# The Sizewell C Project

9.63 Comments at Deadline 6 on Submission from Earlier Submissions and Subsequent Written Submissions to ISH1-ISH6

PINS Reference Number: EN010012

### August 2021

Table 2.1: SZC Co responses to each comment raised by the Environment Agency [REP3-068] following its review of review of the Coastal Geomorphology report "TR543 Modelling of the Temporary and Permanent Beach Landing Facilities"

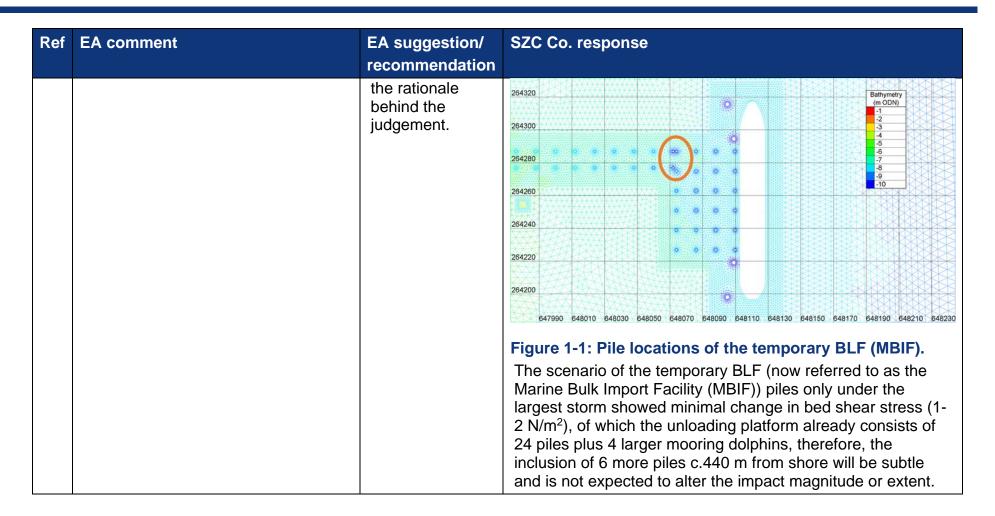
| Ref | EA comment  | EA suggestion/  | SZC Co. response  |
|-----|---|---|---|
| 1   | 'Raking piles and cross braces may be required at the seaward end of the unloading platform for stability' but that these cannot be modelled as 2d models cannot consider diagonal structures. The report states that 'the omission of these small structures will not materially affect the results of the modelling.' | Provide some further information here. E.g. how many raking piles might reasonably be present? What could their footprint be? Were sensitivity tests carried out adding in further regular piles? The current conclusion is seemingly based on expert judgement, but without offering much insight into | Statement (ES) Addendum ([AS-181], Section 2.2, paragraph 2.2.78), there would be six raking piles at the seaward end of the unloading platform. The raking pile diameters are likely to be of the same diameter or smaller than the 1.2 m diameter platform piles meaning they will behave similarly to the existing piles modelled. No sensitivity was conducted to include these extra piles as vertical piles. The proximity of the raking piles to the last seaward row of the unloading platform is similar to the proximity of the last two jetty piles and the first two piles of the unloading platform, which modelling results showed no material interaction as indicated by minimal group scour. |

| Ref | EA comment   | EA suggestion/<br>recommendation   | SZC Co. response  |
|-----|--|--|---|
| 2   | Waves <3m Hs were excluded from the hindcast data used for the TOMOWAC modelling. It is assumed the logic of using higher waves only is for a precautionary assessment and/or because use of operational Hs limits for barge and ship result in a more representative range of Hs at the coast anyway, but further clarity would be useful. E.g. is there confidence that worst case has been considered, and scenario whereby lower waves = smaller reduction required to drop below critical threshold hasn't been underestimated. | Further comment on the rationale behind excluding waves <3m Hs, and how these waves relate to the three wave heights modelled in ARTEMIS would be helpful. | Apologies if the text was not clear enough. No, waves less than 3m have not been excluded from the hindcast; the extremes analysis uses the full 22 years as stated. Waves less than 3 m have been omitted from Figure 11 only in order to highlight the predominant directions of the largest storm waves as there is a greater directional spread of the smaller benign conditions, and the focus of TR543 was on large storm waves.  |
| 3   | 'ARTEMIS results were run for the constant water levels associated with peak flood currents and peak ebb currents, which would generate maximum combined wave-current bed shear stresses.'This is a logical approach when considering worst case erosion scenarios, but could it be missing scenarios where a relatively   | Provide clarity.   | The scenarios with the barge present at the permanent BLF are conducted with a wave height of 0.5 m which is itself a small wave height that causes small changes from a geomorphology perspective (effectively light wave stirring). For example, the average monthly infilling of the grounding pocket is 0.15 m/month during the summer calm conditions (as detailed in Section 4.2.2.3 of Marine Synthesis Report 1, Appendix 20A of the Environment Statement [APP-311]. Under these conditions, changes in bed shear stress are |

| Ref | EA comment  | EA suggestion/ recommendation   | SZC Co. response   |
|-----|---|---|--|
| 4   | 'The reduction in bed shear stress is between 15 –20 N/m2 along both the inner and outer longshore bar. The baseline bed shear stress along the outer bar is 20 –30 N/m2 No area is reduced below the critical threshold.' The figures presented imply that there is the potential for shear stress to drop | Further clarity is needed, and if necessary the possibility for resulting impacts should be considered. | The stated ranges in bed shear stress represent the range of values in bed shear stress change over the area of the largest impact (i.e. the value of bed shear stress is variable within zones of continuous colour bands in the plots due to the nature of the plotting software). Whilst the stated ranges in the text (15-20 & 20-30 N/m²) and the classes of the colour bar in the plots do overlap, for example at 20 N/m², the location of the specific computational nodes where the largest reduction   |
